Proposal for the 03 series of amendments to UN Regulation No. 127 (Pedestrian safety) – document GRSP/2019/18

The text reproduced below was prepared by the experts from OICA to amend the definitions and specifications as well as the Annex 1, Part 1. It is a counterproposal to document ECE/TRANS/WP.29/GRSP/2019/18 submitted by Germany. The modifications to the current text of the UN Regulations are marked in bold for new or strikethrough for deleted characters.

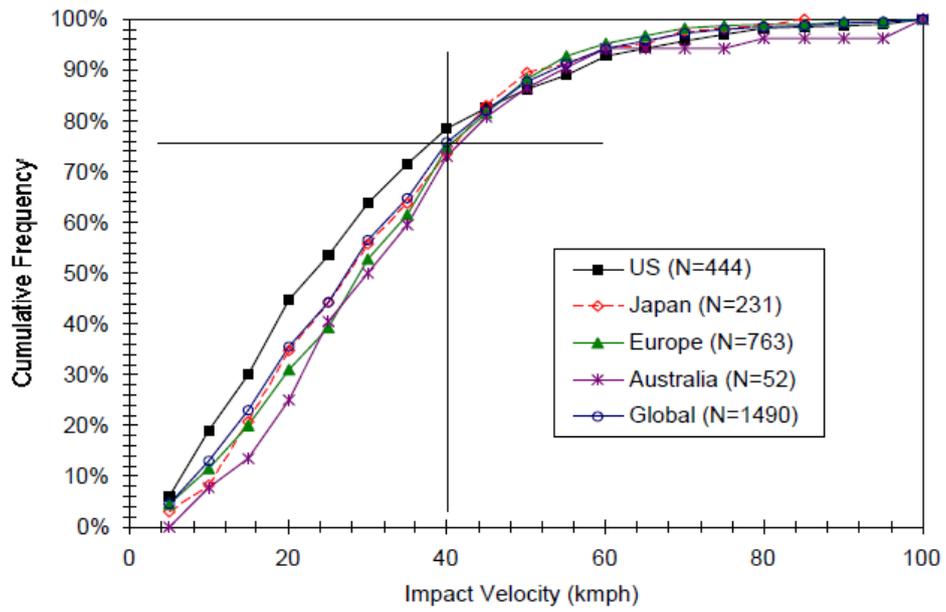
1. UN Regulation No. 127 addresses impacts with a pedestrian up to 40 km/h. Therefore, an impact velocity of 11.1 m/s (40 km/h) has been chosen to address a large amount of Maximum Abbreviated Injury Scale 1+ pedestrian accidents (see diagram below).
